Sussex County Administrative Building
Planning and Zoning Department
2 The Circle
P.O. Box 589
Georgetown, Delaware 19947

Re: Gills Neck Village Center - Rezoning
Tax Parcel No.: 3-35-12.00, Parcel 3.00 (Portion)
DBF #2261J001.F01

RE: Gills Neck Village Center
Developer Response to PLUS review 2015-03-02
Tax Map: 3-35-12.00, Parcel 3.00 (Portion)
DBF No.: 2261J001.F01

On behalf of the Owner / Developer, J.G. Townsend Jr. & Co., we are pleased to submit a revised response to the Office of State Planning's comments for PLUS Review 2015-03-02: The Village Center. On October 9, 2015 we provided a written response to the comments that included a revised schematic site plan that reduces the commercial space (including outparcels) from 235,000 SF to 215,000 SF.

Figure 1: NRCS soil survey mapping update in the immediate vicinity of the proposed construction

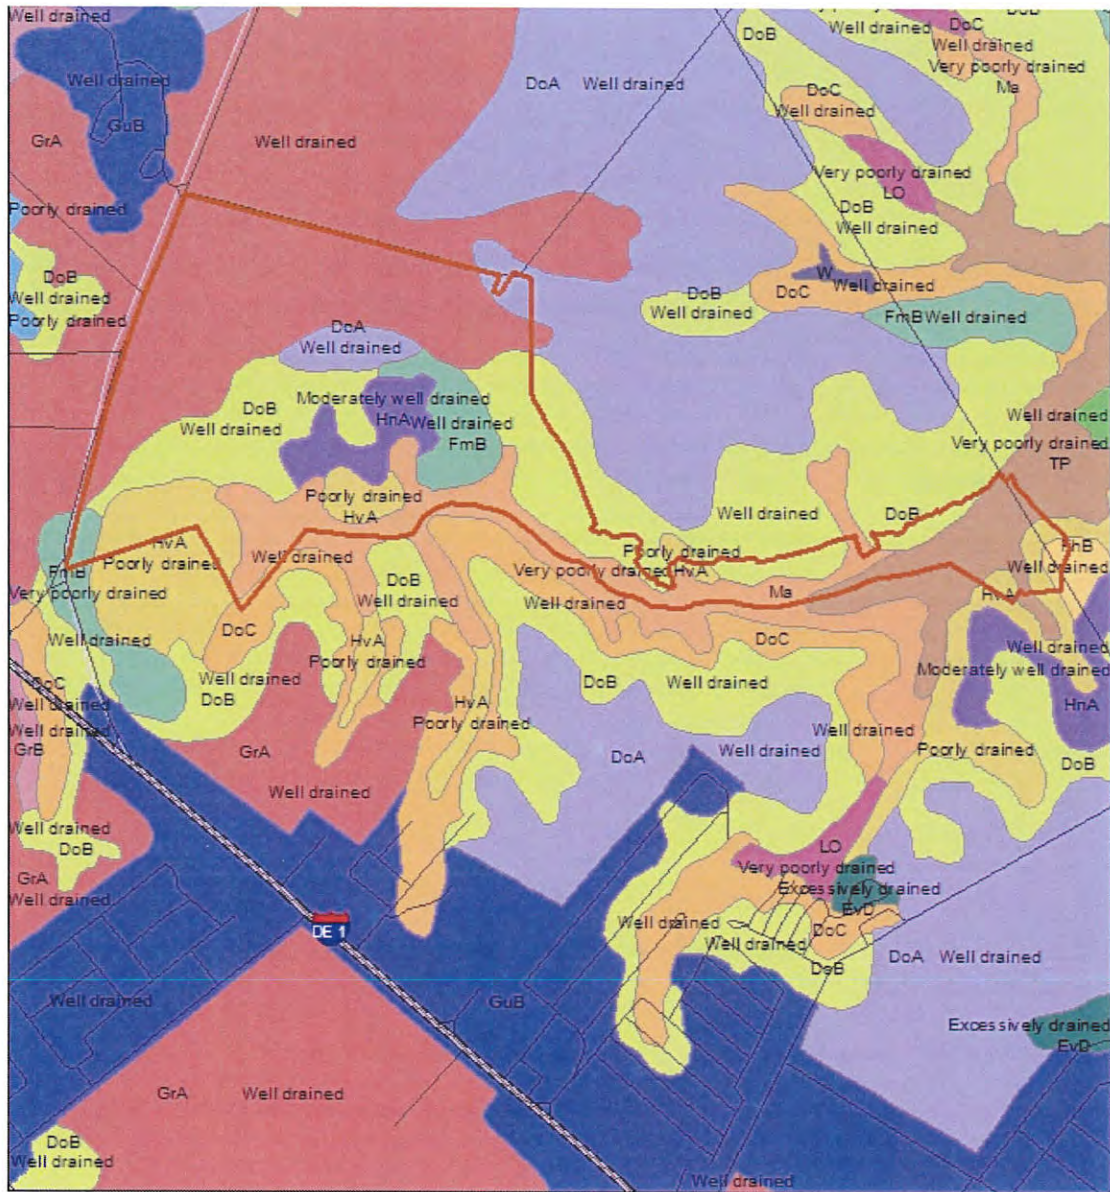
poorly drained wetland associated (hydric) soils that are considered to have severe limitations for development (considered unsuitable). Therefore, DNREC strongly recommends that the applicant avoid development in all hydric soil mapping units. (Figure 1).

Original Response: The soils on the proposed Gills Neck Village Center property are all well drained soils and do not have any limitations on the development of this project.

Revised Response: There is no change from the original response.
